TELEDYNE CONTINENTAL[®] AIRCRAFT ENGINE SERVICE INFORMATION LETTER

SIL97-12

SUBJECT: INSTALLATION OF STARTER ADAPTER SHAFT SEAL AND ASSOCIATED PARTS.

PURPOSE: ANNOUNCES NEW STARTER ADAPTER SHAFT SEAL SLEEVE P/N 654229 AND PROVIDES INSTRUCTIONS FOR REMOVAL AND INSTALLATION OF THE STARTER ADAPTER SHAFT SEAL AND SLEEVE.

FIGURE 1.

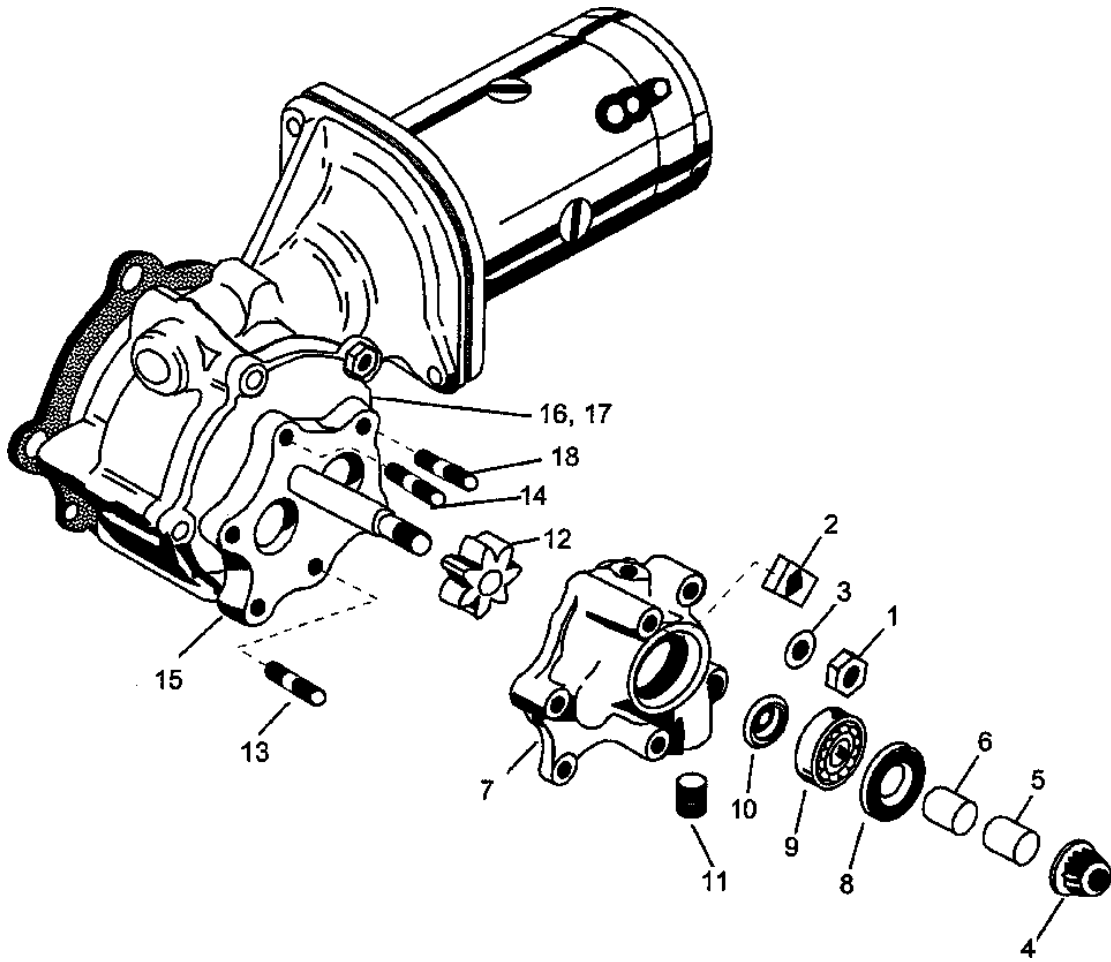
5. Remove the starter motor in accordance with the instructions provided in the applicable engine overhaul manual or aircraft maintenance manual.
6. Reference Figure 1. Using a 12 point deep socket loosen and remove nut (4) and spacer (5) or air-conditioning compressor drive sheeve and shims and sleeve (6). Do not misplace or discard shims as they will need to be reinstalled to assure correct alignment of the air-conditioning compressor drive sheeve, idle sheeve and compressor sheeve.

9. Remove five sets of hardware (1 & 3) and seal retaining clip (2).
10. Remove body (7) from the starter adapter.

- will need to be removed from the body (7).
11. Remove oil seal (8) from body (7).
 12. Remove bearing (9) and spacer (10) from body (7). Do not discard these items, they will be reinstalled.
 13. Clean all parts as required in accordance with the instructions provided in the applicable engine overhaul manual.
 14. Dimensionally inspect sleeve (6).
 - A. Sleeve P/N 654229 has an outside diameter of .812 inches to .814 inches. The outside diameter is unplated.
 - B. Earlier sleeve P/N 640733 has an outside diameter of .808 inches to .810 inches. The outside diameter is cadmium plated.
 15. Replace sleeve P/N 640733, regardless of condition, with sleeve P/N 654229.
 16. Replace any worn or damaged sleeve with new P/N 654229.
 17. Inspect bearing (9) and spacer (10) for wear and damage. Replace if wear or damage is indicated.

FIGURE 2.

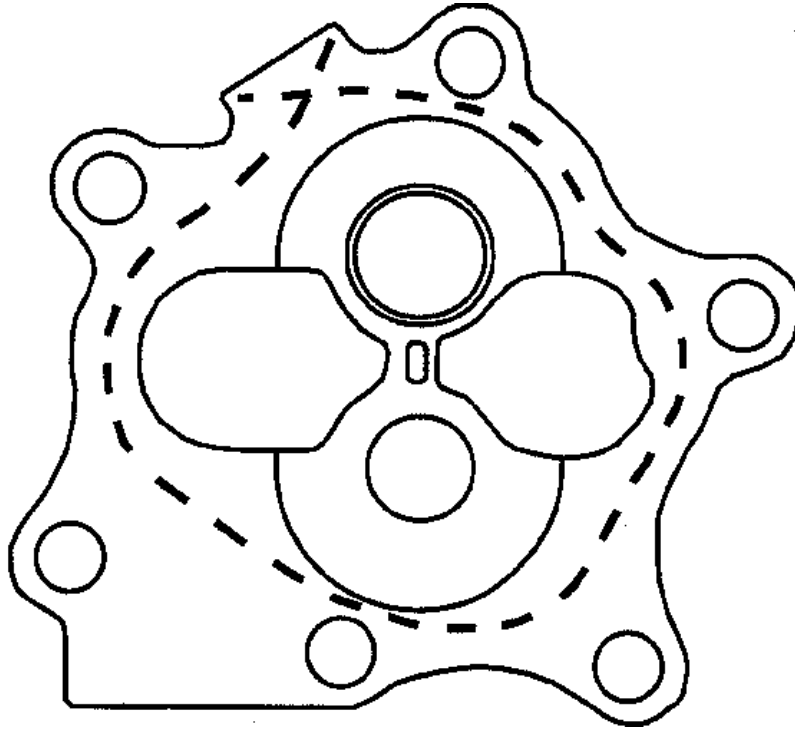
4. Using Aviation Permatex, P/N646942, lightly coat the parting surface of body (7). Allow the Permatex to set for a few minutes until slightly tacky. See figure 2.

5. Using Grade 3 Silk Thread, P/N 641543, apply a single line of thread over the Permatex surface of body (7). See Figure 2.
6. Insure that gear (12) is correctly positioned.

FIGURE 3.

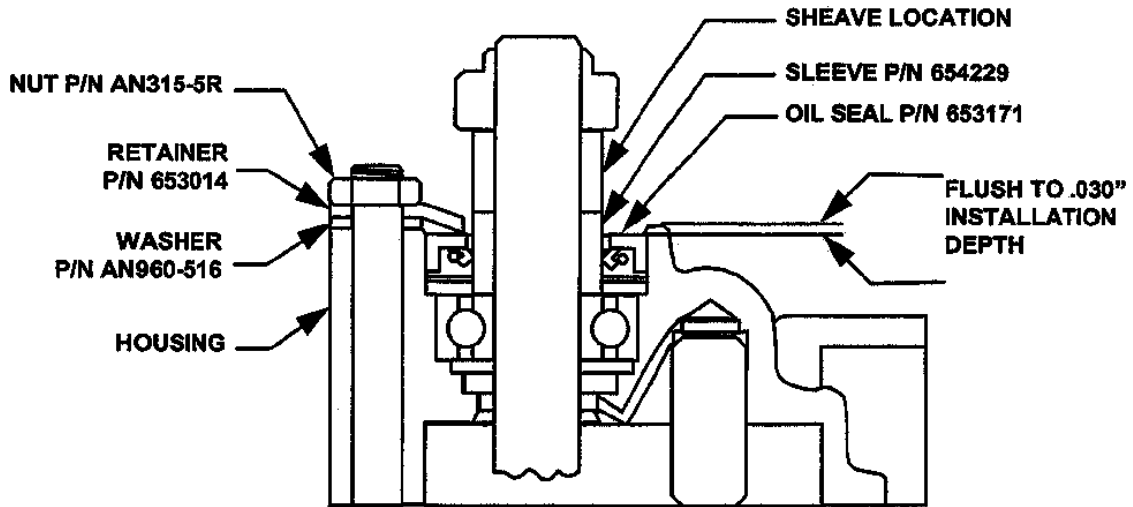
11. Position the assembled oil seal (8) and sleeve (6) over the starter adapter shaft and into the seal bore in body (7). Lightly tap or press the seal and sleeve (8 and 6) as an assembly into its recess in body (7). The seal must be positioned flush with or within .030 inches below the surface of its recess. See Figure 3.
